UNITED STATES PATENT AND TRADEMARK OFFICE

APPLICATION NO.	FILING DATE	FIRST NAMED INVENTOR	ATTORNEY DOCKET NO.	CONFIRMATION NO.
10/014,519	12/14/2001	Betty Wu	10255-028-999	3927

Office Action Summary

DETAILED ACTION

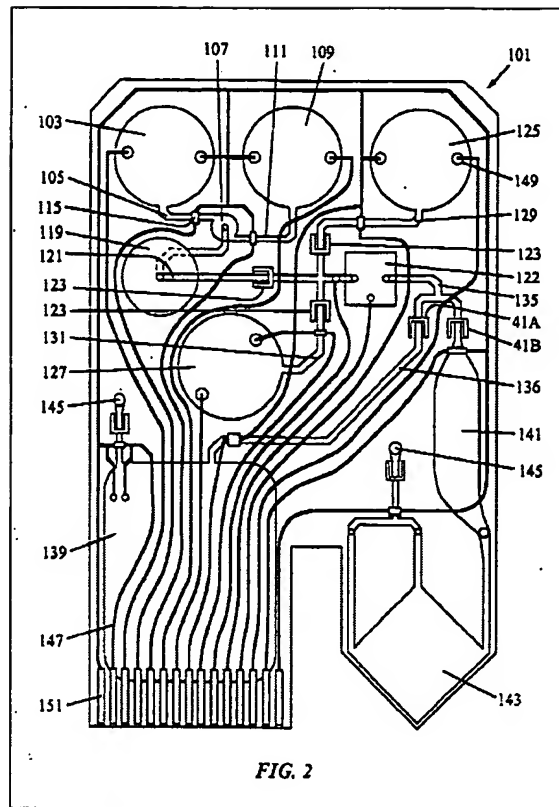
Regarding claims 1, 9, 12, 13, 16, 23, 26 & 39, Pourahmadi teaches an apparatus (cartridge 101) comprising: a sample port (103); a channel (105); and a lysing zone (lysing chamber 119) (see paragraph 0048; figure 2).

Pourahmadi does not specifically teach the further incorporation of a gas actuator comprising a thermopneumatic actuator and an associated vent structure to facilitate sample fluid flow within the disclosed apparatus. Pourahmadi does teach that a fluid sample may be introduced into the cartridge by a variety of means, manual or automated (see paragraph 0078). Pourahmadi teaches that for automated sample introduction, additional cartridge design features are employed and, in many cases, impart specimen accession functionality directly into the cartridge (see paragraph 0080). Pourahmadi does further teach that a fluid motive source comprising a pneumatic pressure source can be internally incorporated within the cartridge apparatus for facilitating sample fluid transport (see paragraph 0067).

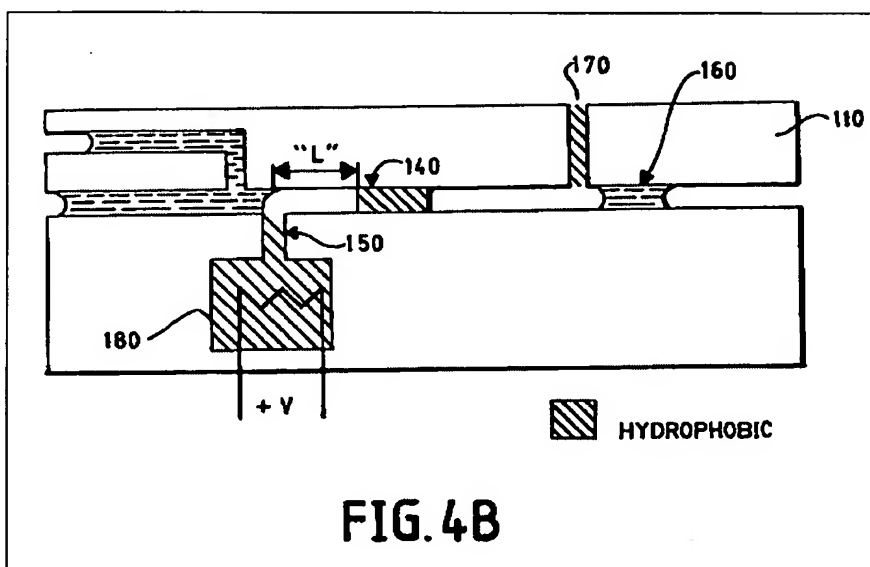
Handique teaches a thermopneumatic apparatus for facilitating fluid transport in microfluidic devices (see col. 13, line 60 – col. 15, line 40; figures 3A, 3B, 4A & 4B). As shown

in figure 4B, the system taught by Handique comprises a thermopneumatic actuating system denoted by 180, a hydrophobic gas vent (170), and an outlet, which is located to the right of the sample (160) and at the end of the channel containing the sample, from which the sample is transferred for further processing, such as to a lysing chamber for cell lysing, when integrated within an analytical microfluidic system.
